Technical Tip

Model: HTR-330/530, TX-SR303/SR503

Subject: General troubleshooting for Protect problem.

Service Bulletin

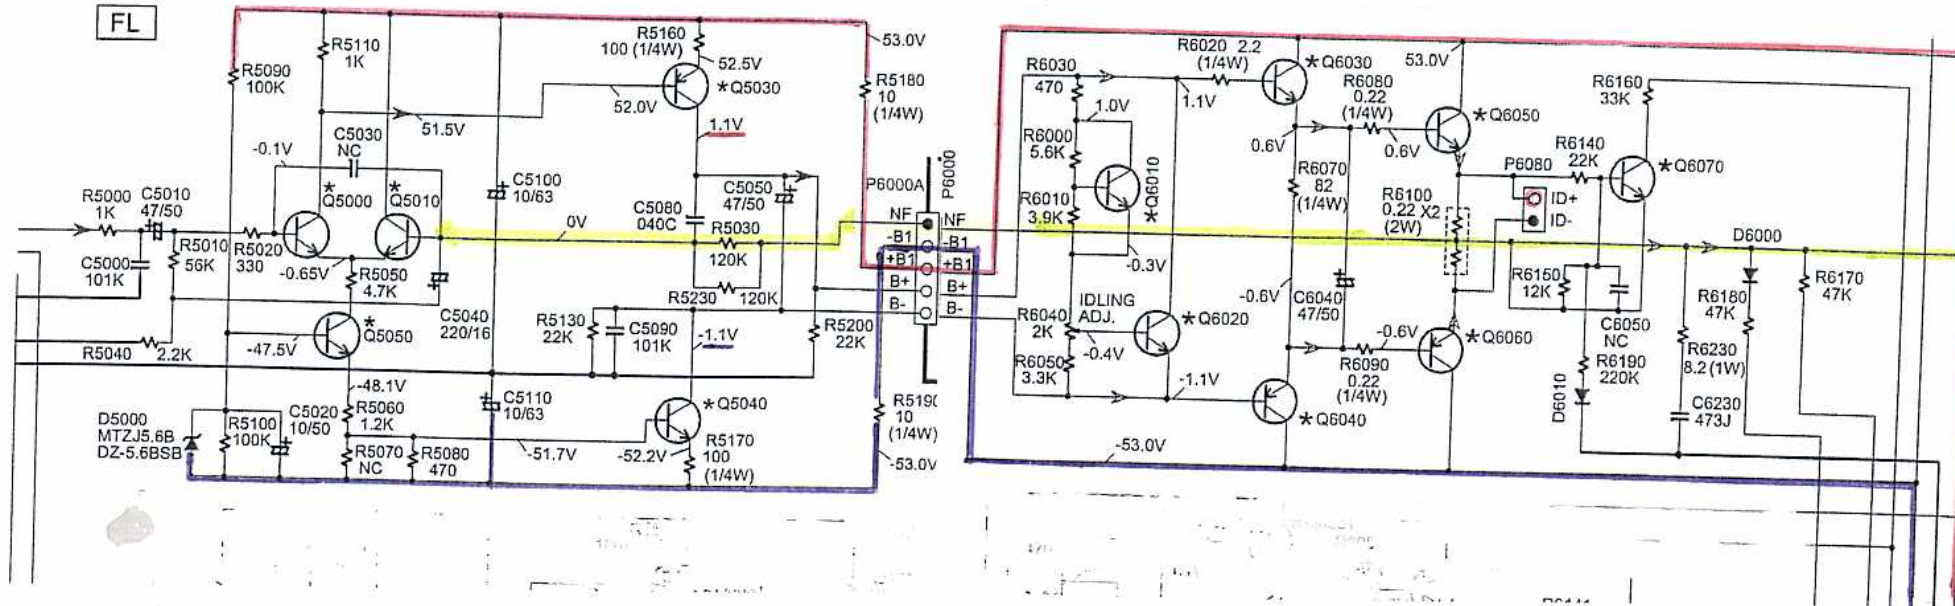
- 1 . Normal audio using analog inputs. Do you have all Dolby surround sound ?
- 2 . All DSP voltages are normal ? Did all supply voltage go to all ICs ? +5vDSP, 2.5V, +3.3V... +7v, -7V..
- 3 . Input sel IC. Use CD analog input audio signal (ADRT+, ADRT- and ADLT+, ADLT-) out to DAC IC ?
Surround analog signal out (DAC L, DAC R, DAC C, DAC SW, DAC LS, DAC RS, DAC SB* back to Input sel. IC.
Pin 1 to pin8 out to p5504. (Same as pre out) check Mutting transistors Q5600 to Q5617 .
- 4 . When use digital input signal did digital light up on display ?
If missing 3.3v, 2.5v 5vdsp (on Reg IC Q5640) to DSP ICs will disable DSP function. (U05 Amplifer PC board)

Please use TX-SR502 as sample Technical Tip Troubleshooting.

When you need Tech help Please use Tech Email and give us Voltage and signal info. What voltage on DSP ICs and where you lost audio signal ? What you have on input IC Data line
Check with TX-SR502 Troubleshooting tips for the Microprocessor and Audio Select IC

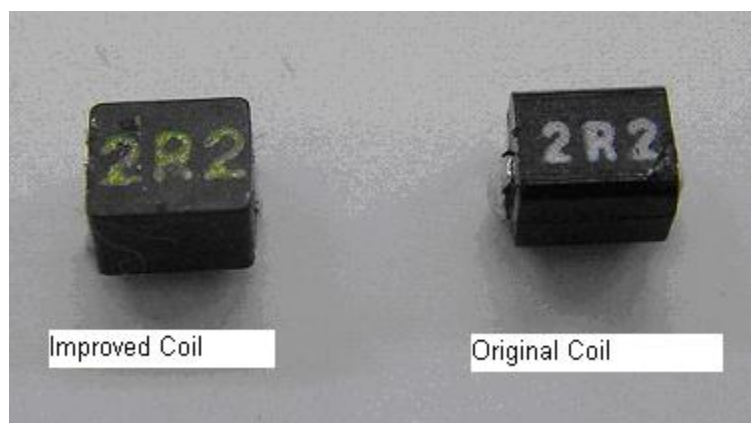
Symptom: No sound in Surround mode. Coil L921 which is located on the DSP board may have opened due to in rush current.

Solution: Check coil L921, if open, replace L921 with the improved part (green print).
